REMARKS

Claims 10-17 are pending in the present application.

Drawings

FIG.9
PRIOR ART

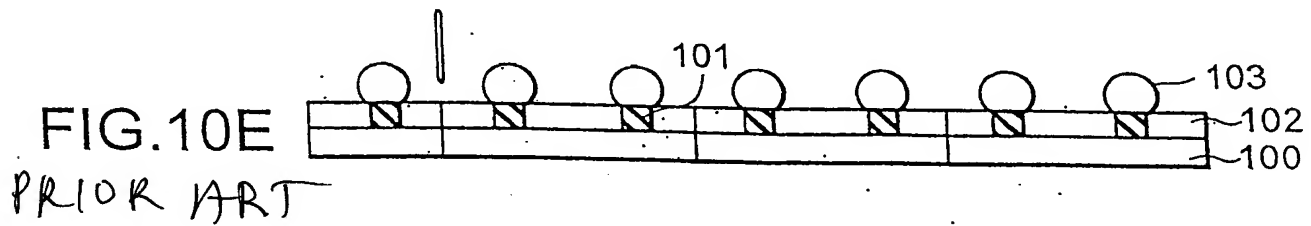
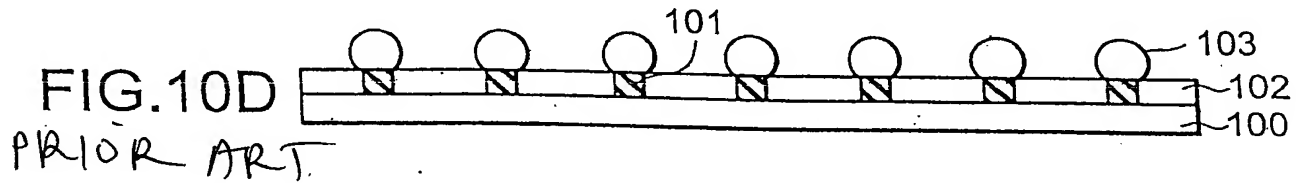
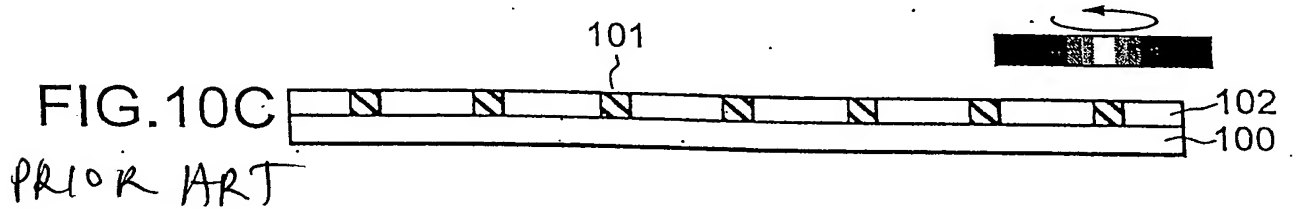
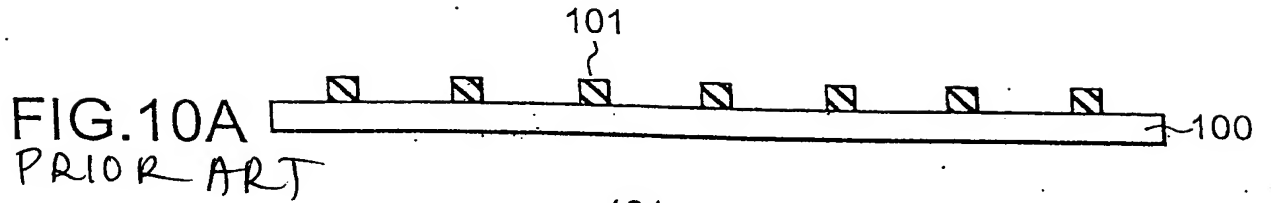
The Examiner has required that Figs. 9-12 be designated as "PRIOR ART". Accordingly, enclosed are (3) red-inked drawing Annotated Sheets, wherein Figs. 9-12 have been denoted as "PRIOR ART", as required. Also enclosed are three (3) drawing Replacement Sheets, incorporating the above noted corrections. **The Examiner is respectfully requested to acknowledge receipt and acceptance of the drawing Replacement Sheets.**
